PRODUCT CHANGE NOTICE

PCN#21-060

Change of plastic substrate

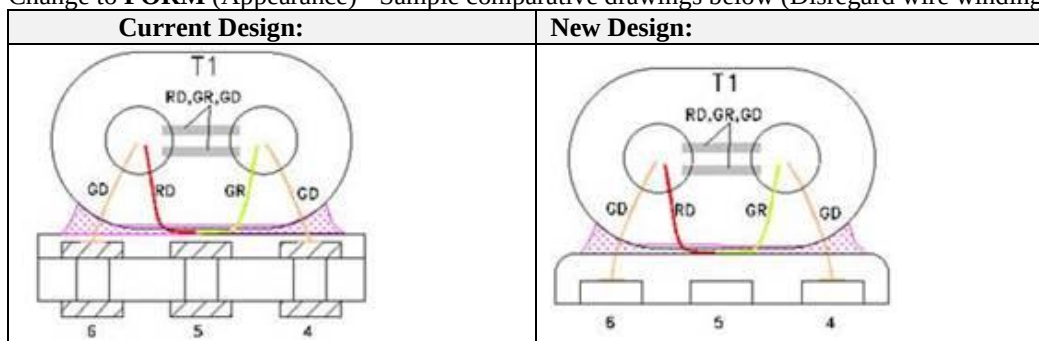
- No change to **Function** (Performance)
- Change to **FIT** (Dimension)– Drop in footprint equivalent, Reduction in total height
- Change to **FORM** (Appearance) - Sample comparative drawings below (Disregard wire windings)

AT224-1A

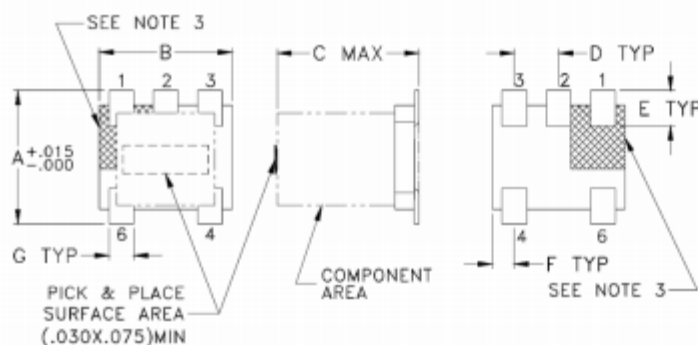
Change of appearance of plastic substrate

- No change in Fit, Form or Function
- Slight change in appearance of the substrate
